Able Marine Energy Park

Material Change 2

**ABLE MARINE ENERGY PARK MATERIAL CHANGE 2 (AMEP MC2)
APPLICANT'S COMMENTS ON THE RELEVANT REPRESENTATIONS**

December 2021

Figure 12.1: Indicative AMEP Masterplan with Area benefiting from Other Operational Consents Delineated by Dashed Line.

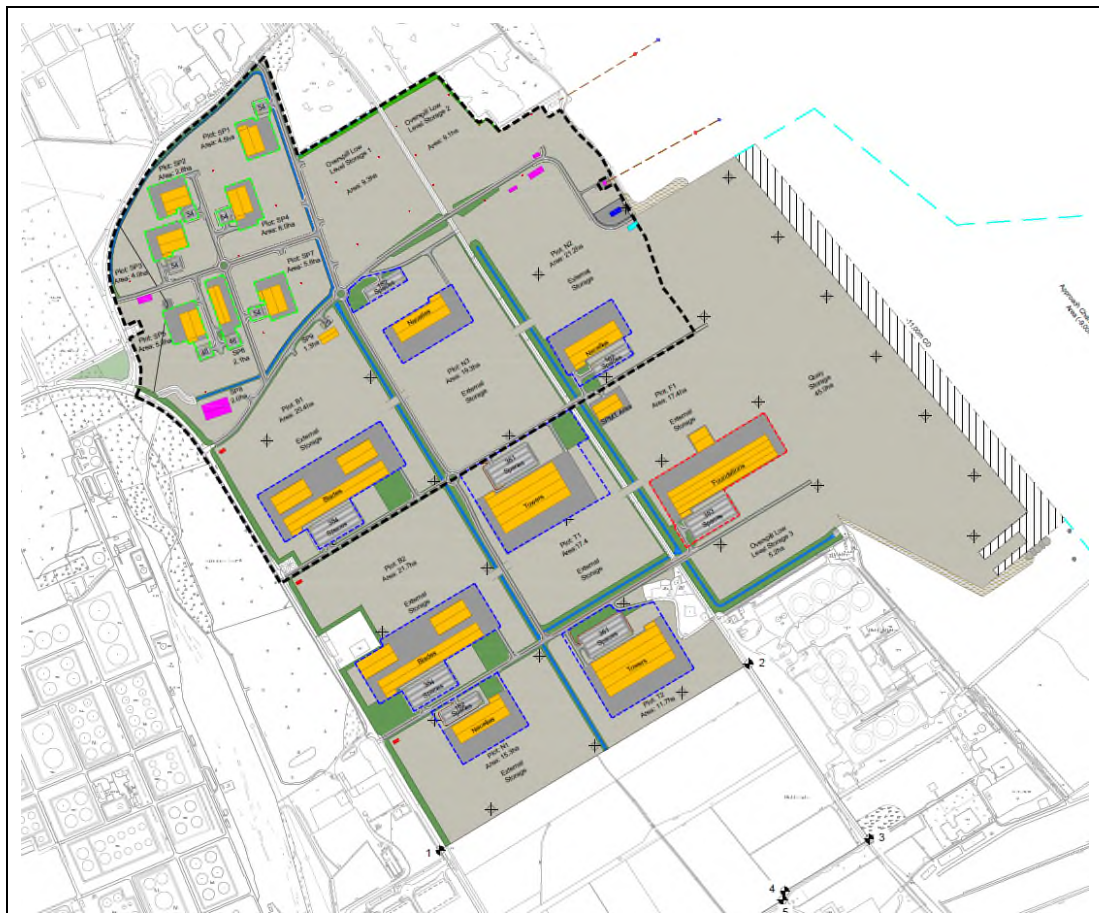
1. Scope of assessment: subsequent to the DCO being made, AHPL has carried out development on the AMEP site under separate planning applications, for different uses not related to AMEP. The ES (para 1.2.7) states that none of the planning permissions granted in respect of the AMEP site in the period since the DCO was submitted will prevent or alter the delivery of AMEP for the purpose for which it was originally intended (i.e. as a bespoke port facility to facilitate offshore windfarm and other renewable energy development). It would be helpful to have clarity in how these different developments will interact, so that as neighbours and affected parties we can fully understand the impacts of the consents that will actually be built out, whether fully or in part. Currently, the application assumes AMEP will be fully built out; if it is possible that it will not be and other existing uses will remain, this will be a different development to that envisaged by the DCO and Material Change 2 application and it should be assessed. In addition, AHPL should be required to confirm whether the revised phasing of the quay wall envisages a partial implementation i.e. a scenario where the whole quay wall is

- 12.6 In relation to extant consents, those parts of the application site benefitting from an historic operational consent are shown in Figure 12.1.

- 12.7 The operations permitted within the AMEP site by these historic permissions are limited to port related storage operations and car workshops, and in some areas simply to vehicle storage and distribution. By contrast, the operations permitted by the DCO are much broader in scope and include for the manufacture, assembly as well as storage of items associated with the offshore renewable energy sector. This includes for the construction and operation of 10 factories within the delineated area in Figure 12.1. It is not plausible that the construction and operation of ten additional factories results in less environmental impact than simply storing port related goods in accordance with existing consents. Accordingly, there is not likely to be a more significant environmental effect arising from an interim development scenario as opposed to the completed scheme. Further, and in any event, it is evident from both the original ES and the UES that the most significant environmental effects arise during construction and not during operation.
